Pentium® III Xeon™ Processor Specification Update

Release Date: November 1999

Order Number: 244460-008

G56. V_{IH} Specification Deviation on Processor RS0# Input

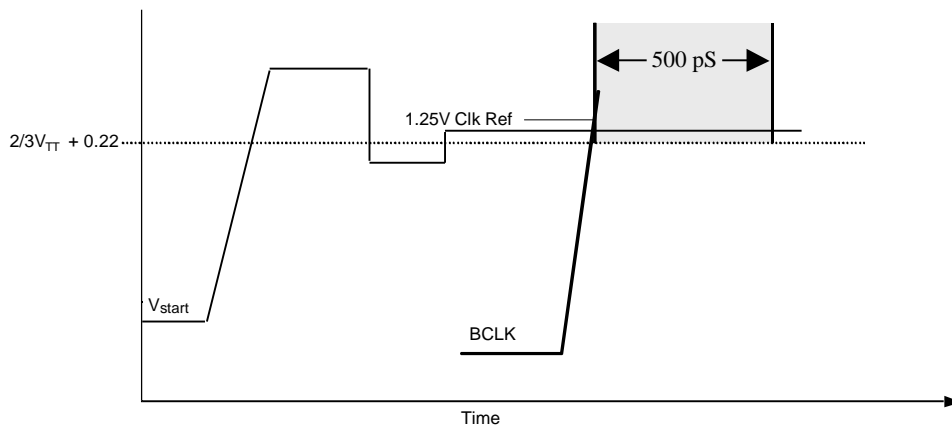
Problem: The RS0# signal of the 550 MHz Pentium III Xeon processor with 512K and 1M of cache has been found to deviate from the published specification for the minimum input high voltage, $V_{IH(MIN)}$, as published in the *Pentium® III Xeon™ Processor at 500 MHz and 550 MHz Datasheet*.

The published AGTL+ AC specification for $V_{IH(MIN)}$ is $(2/3 \cdot V_{TT}) + 0.1$ Volts.
